Lake Merritt Station Area Plan

Final Environmental Impact Report

July 2014

Prepared for the **City of Oakland** by

Figure 2.1-2
Planning Boundary

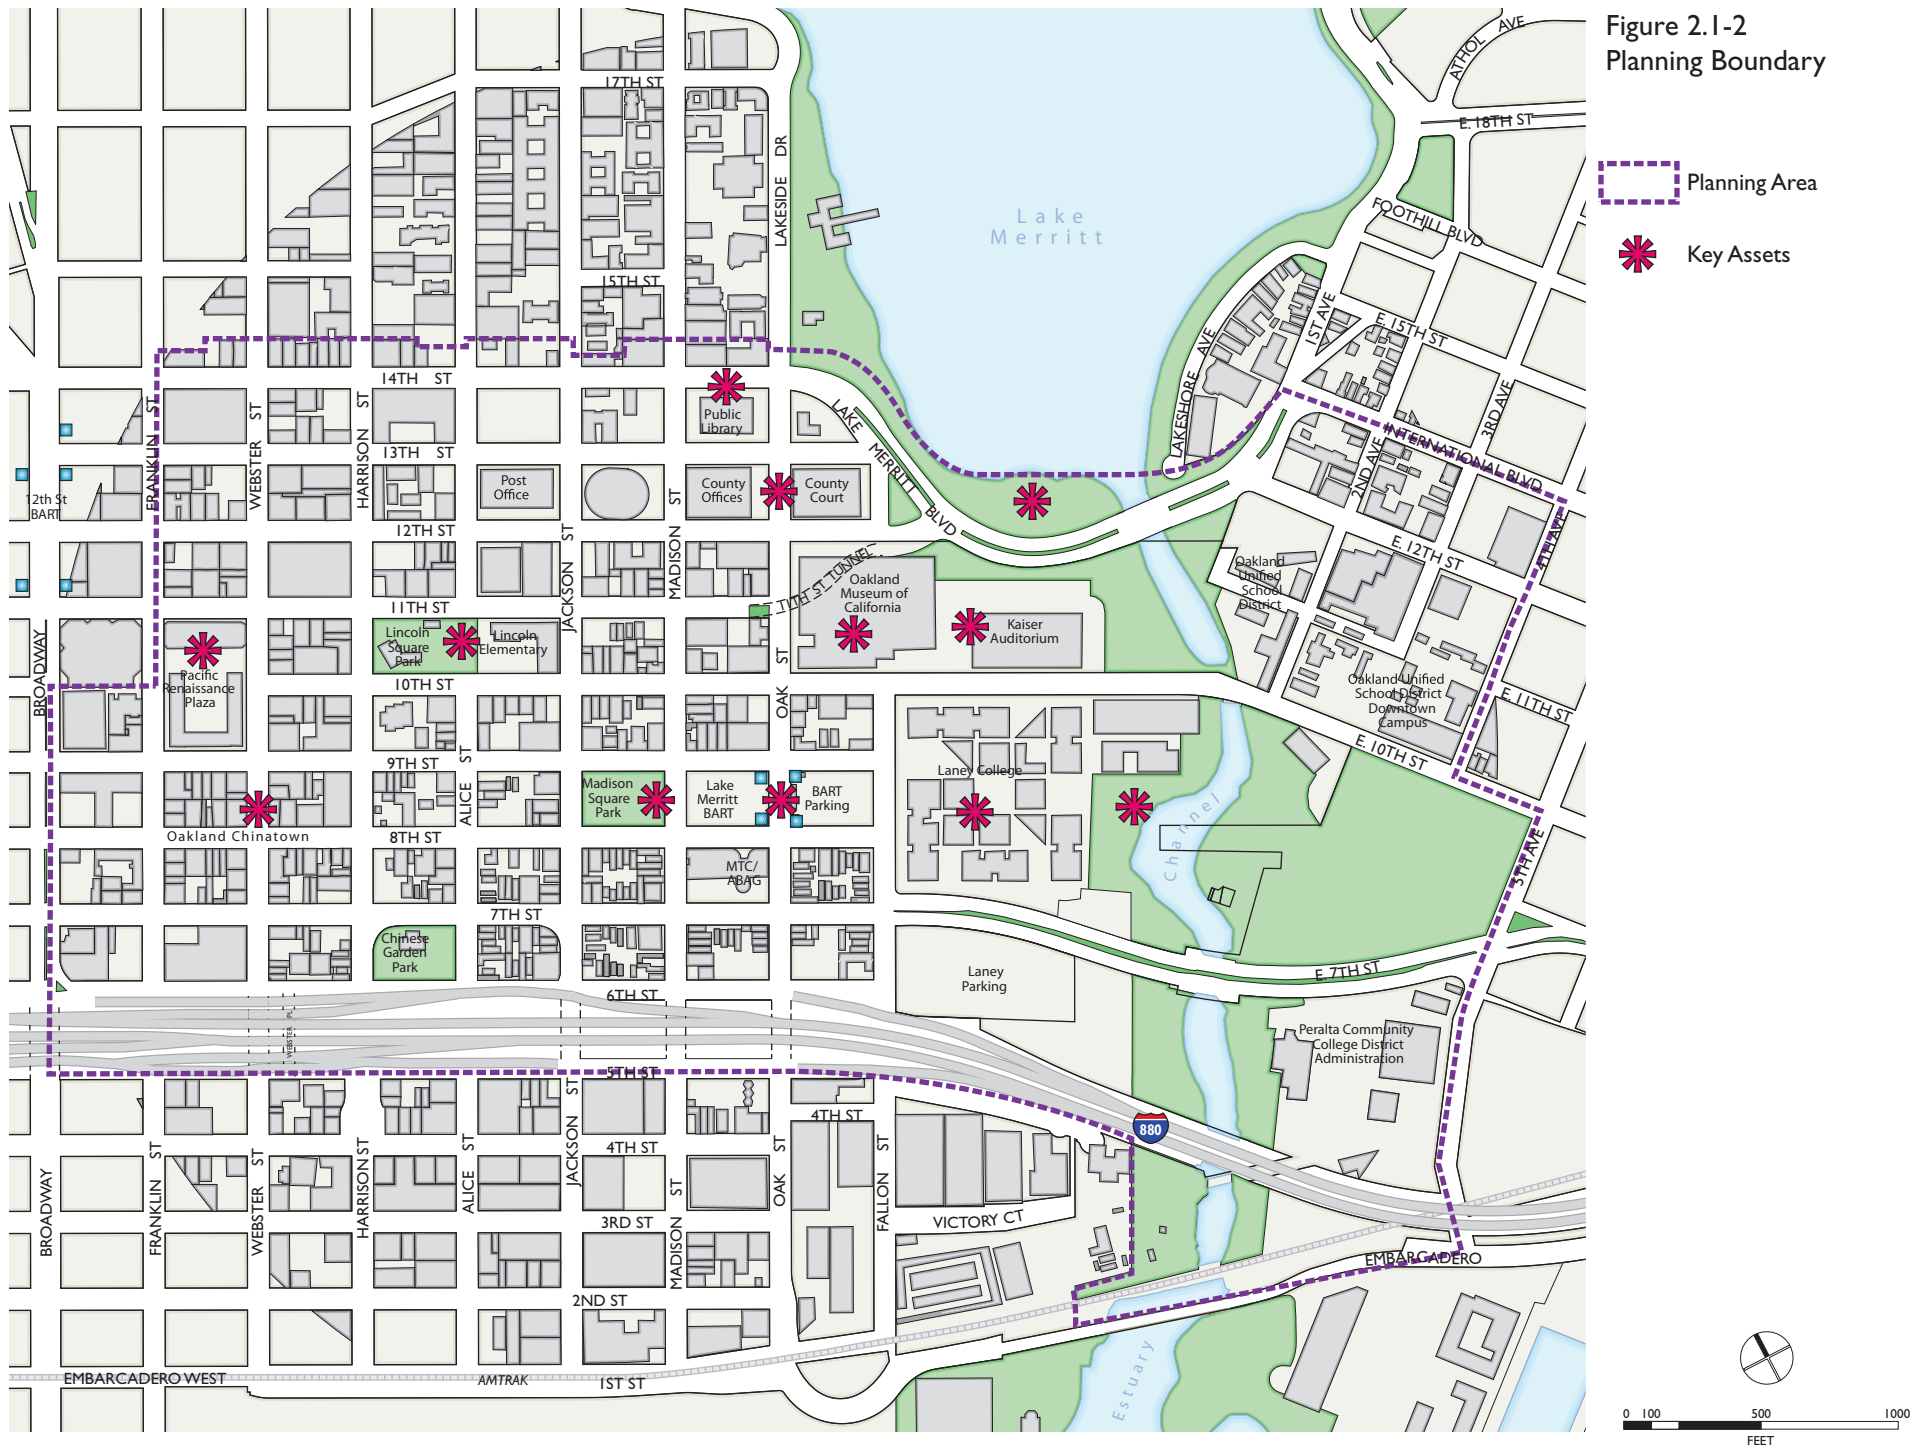
Figure 2.1-2: Planning Boundary is revised, removing the numbers from the map.

- Figure 2.1-2: Planning Boundary is revised, removing the numbers from the map. These numbers refer to “Key Assets” shown as symbols on the map. The map key identifying those “key assets” is not included in the EIR map, so the numbers should be removed.

- C1-1: The revised Planning Boundary map (Figure 2.1-2 in the DEIR) is included in Chapter 3 of this FEIR.
- C1-2: The comment notes the current timing of traffic signals along Madison to facilitate traffic movement and good connections to I-880. The proposed narrowing and bike lane on Madison would affect the traffic operations resulting in impacts requiring optimization of signal timing and corridor signal coordination (Mitigation Measures TRAN 14 and TRAN 17). These measures would allow for modifications to signals to facilitate the smooth progression of traffic with fewer stops and starts as desired by the comment.

Figure 2.3-1
Draft Area Character

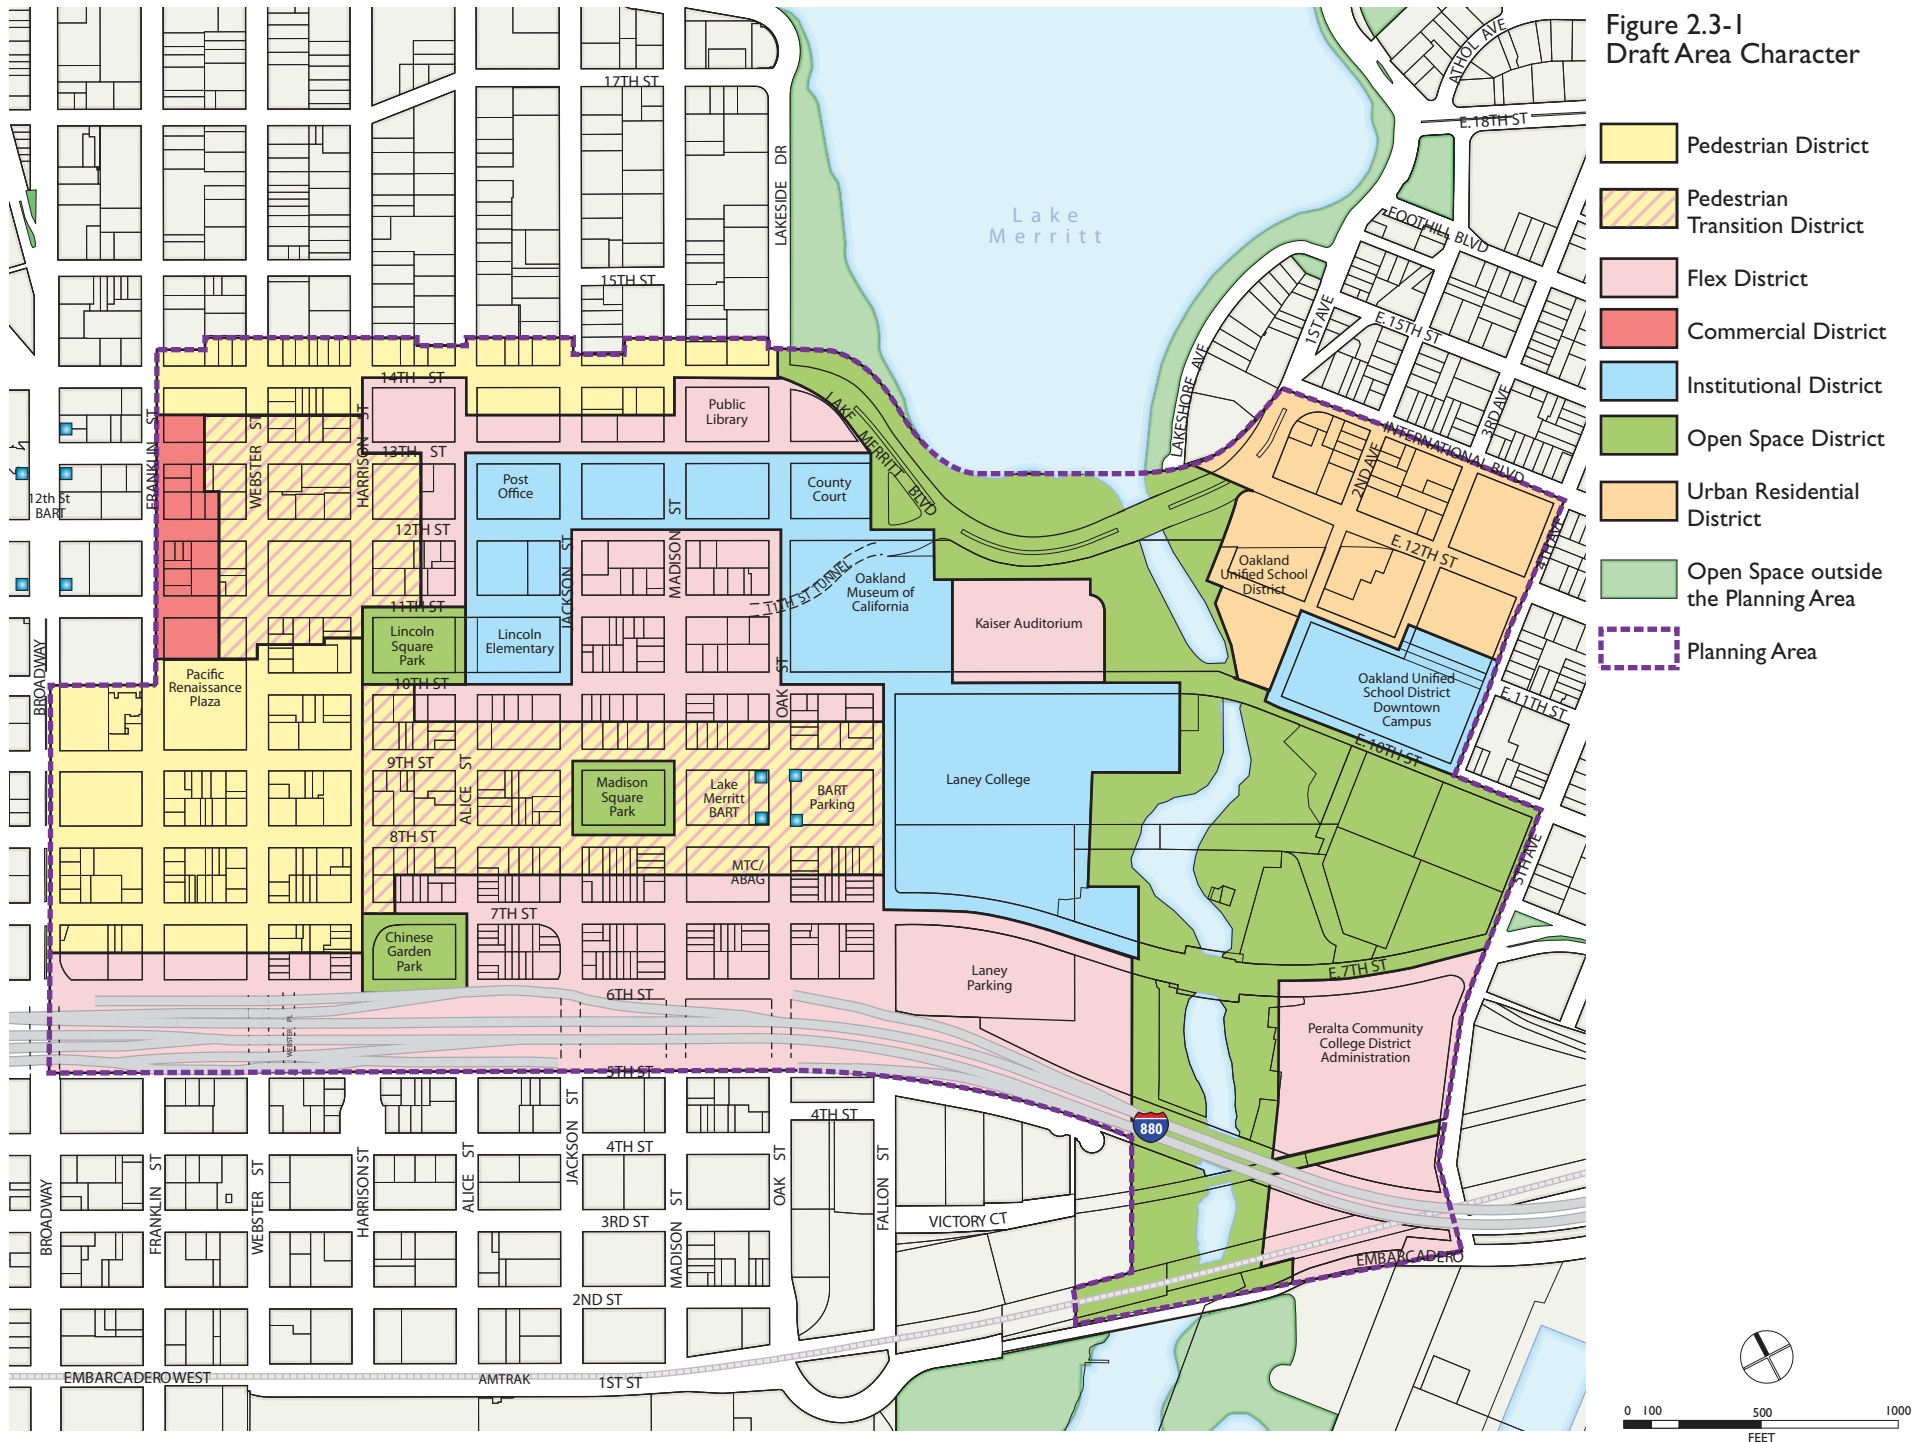
Figure 2.3-1: Draft Area Character is revised to extend the Open Space district further from the Channel between I-880 and 7th Street.

Figure 2.3-2
Draft Proposed
Height Areas

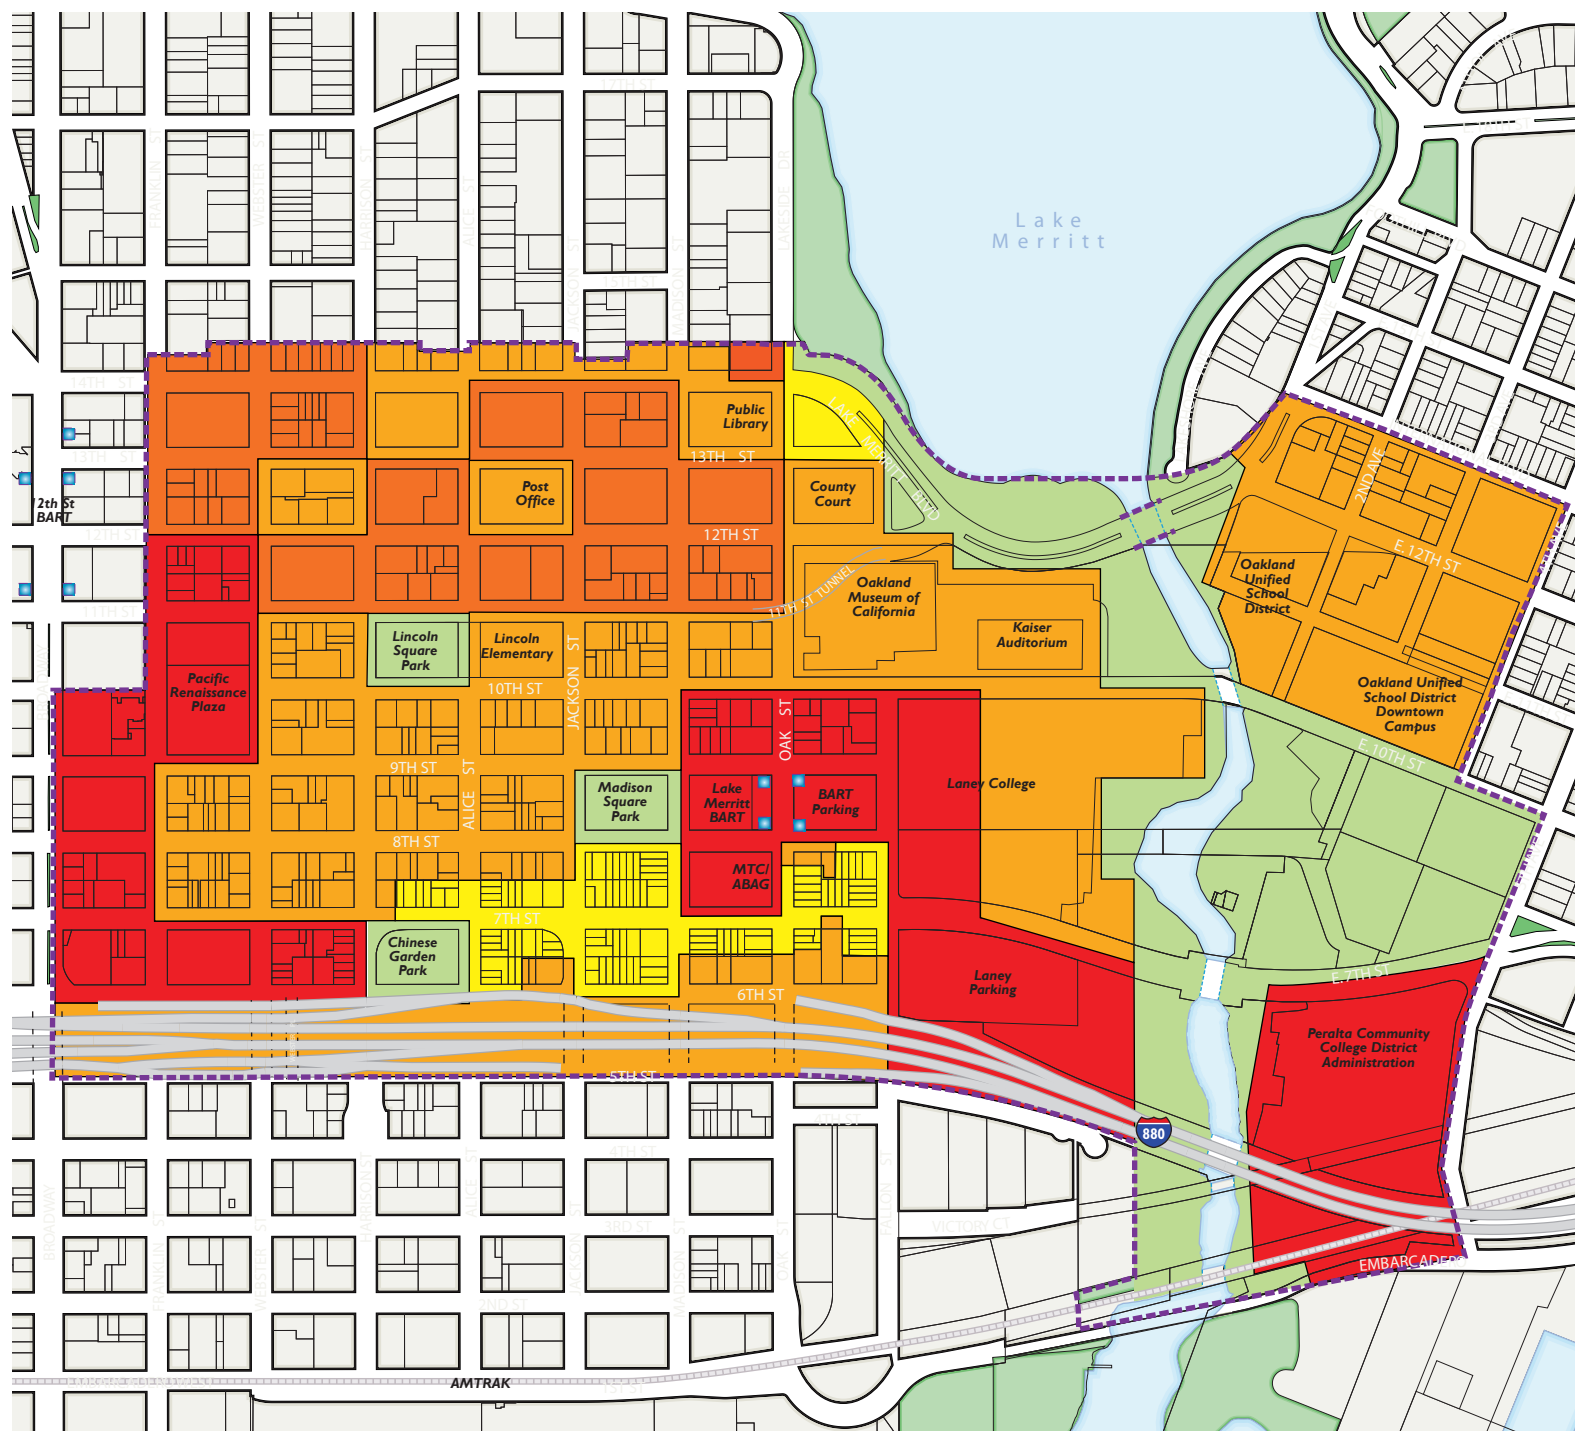
Figure 2.3-2: Draft Proposed Height Areas is revised to reflect the Plan changes described in Chapter 2 of this FEIR.

Figure 2.3-3
Phase I
Circulation Improvement

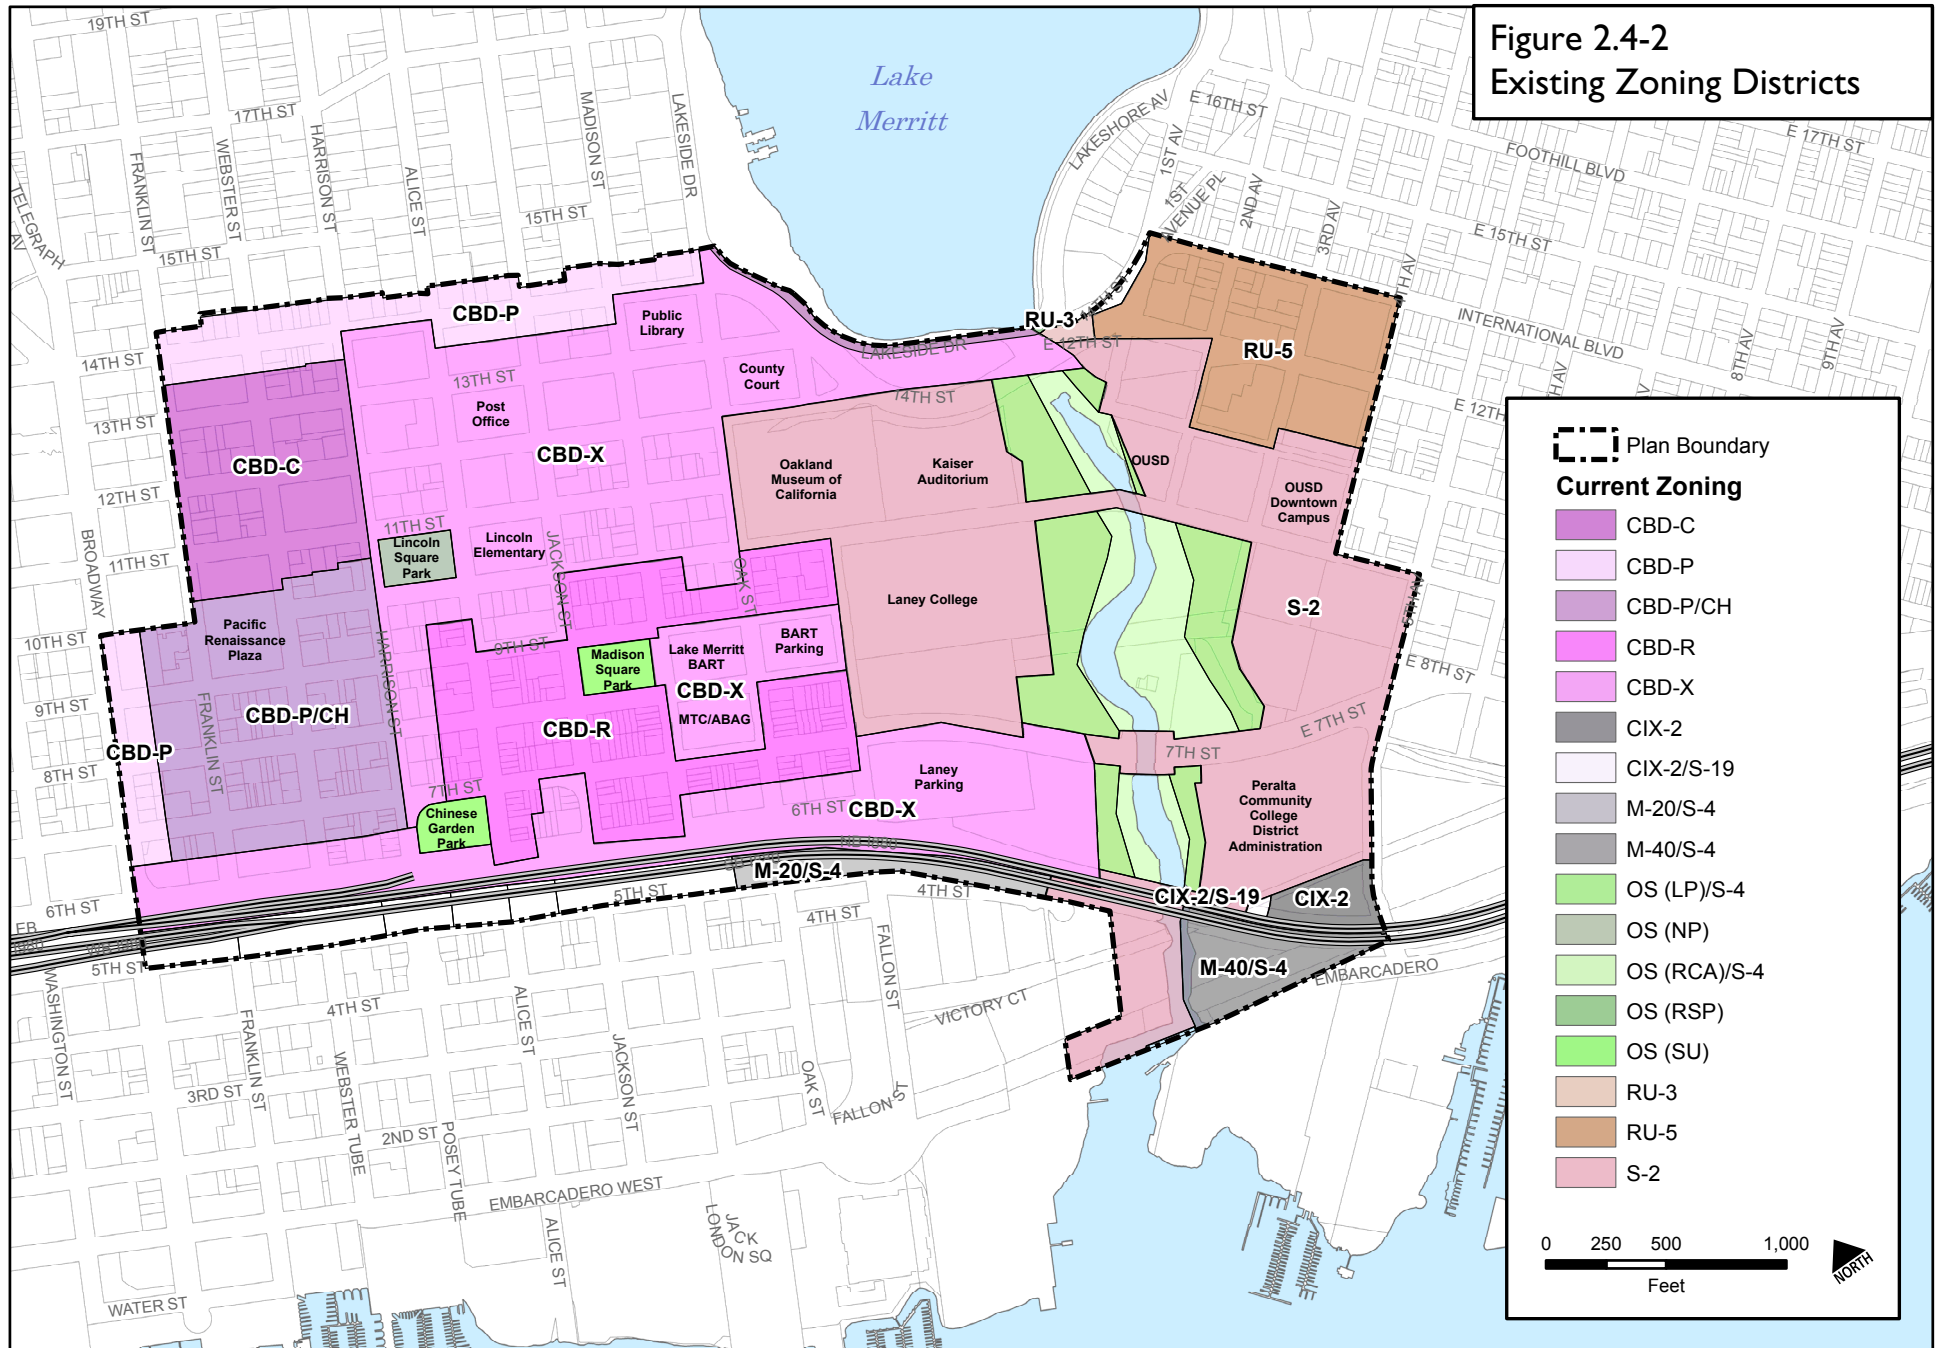
Figure 2.3-3: Phase I Circulation Improvement is revised to add a proposed bulbout to the intersection of 7th and Jackson Streets, and make the Planning Area boundary symbol consistent with other maps.

- Figure 2.3-3: Phase I Circulation Improvement is revised to add proposed improvements to the intersection of 7th and Jackson Streets, and make the Planning Area boundary symbol consistent with other maps.

The DEIR indicates that the City is planning bulb outs or sidewalk widening at 7th and Harrison. DEIR at Figure 2.3-3. This intersection lies at the mouth of the Tubes. The DEIR fails to analyze the transportation impacts of this improvement on traffic exiting the tubes.

- A8-18: As shown in Figure 2.3-3 of the DEIR, bulb outs at 7th and Harrison are being considered as a Phase I action to reduce crossing distances for pedestrians at this location. Phase I transportation improvements are not expected to have any significant adverse impact on the environment, since they do not involve changes to lane configurations, thus causing no adverse changes to circulation for any mode of travel.
